<b>Development description</b> Outline application for the demolition of existing buildings and residential development of up to 76 dwellings including the creation of a new vehicular access and pedestrian accesses, open space, landscape planting and surface water attenuation (all matters reserved except access).	<b>App. Ref</b> 19/03416/OUT
<b>Site address</b> Land at Manor Farm Combe Hill Templecombe Somerset	<b>Response date</b> 24 <sup>th</sup> July 2020
<b>Environment Team response by</b> Charles Potterton (Consultant Landscape Architect)	<b>Case Officer</b> David Kenyon
<b>Summary response</b>	
No Objection or comments	
No Objection – subject to conditions described below	
Object in principle	
Not acceptable in its current format	
<span style="float: right;">✓</span>	
<b>Detailed response</b>	
<ol style="list-style-type: none"> <li>1.     <b>Introduction &amp; background.</b></li>   <li>2.     I have visited the site and its surroundings. I have read all the relevant documents submitted in relation to the application.</li>   <li>3.     <b>The site.</b></li>   <li>4.     The site sits on the east side of Templecombe / A357. It lies outside the settlement boundary. It is locate

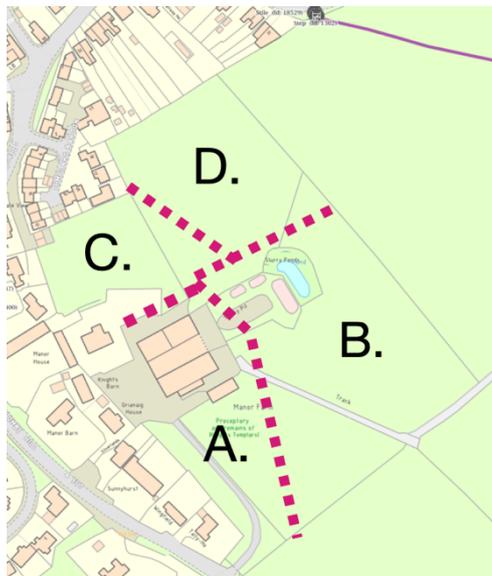
22. A finer grained analysis constraints and opportunities shows that the site can be divided into a number of distinct 'areas' (labelled only to aid future identification / discussion) –

- A.** Site entrance and flat plateau (to include existing car park / buildings)
  - B.** Eastern and southern facing slopes (outer part of the site)
  - C.** Rectangular area south of Templars Barton and east of Temple View & Templars Retreat (smaller internal area)

- D.** Lower area west of PROW WN 29/12 and south of No's 17-35 High St

23. In respect of Area **A**, I consider that there is potential for development in this area but development must not move any further east than a line drawn along the back of the existing shed. To move any further out would cause significant visual harm (and harm to wider landscape character). The removal of the farm buildings may be a benefit.

24. In respect of Area **B**, I consider that this is the most sensitive in terms of wider visual impact and resulting harms to wider landscape character. There should be no built development in this area and the focus must be providing appropriate mitigation for any development on Area A.

26. With Area **C**, I am aware that here is a combined and enhanced sensitivity around archaeology and setting of the listed building. There is also a close relationship with existing residential properties at Templars Barton. I do not think there should be any built development in this sensitive area, but it does need an appropriate soft landscape solution that addresses these issues.

27. Lastly, Area **D**. This is closely related to the properties along High St and East St. It is also closest to the PROW. Having said that, it does sit much lower in the landscape and I consider that there is some scope for built development here. I am aware of the need to also balance and 'feather into' the issues related to Area **C** and that will inevitably restrict development.
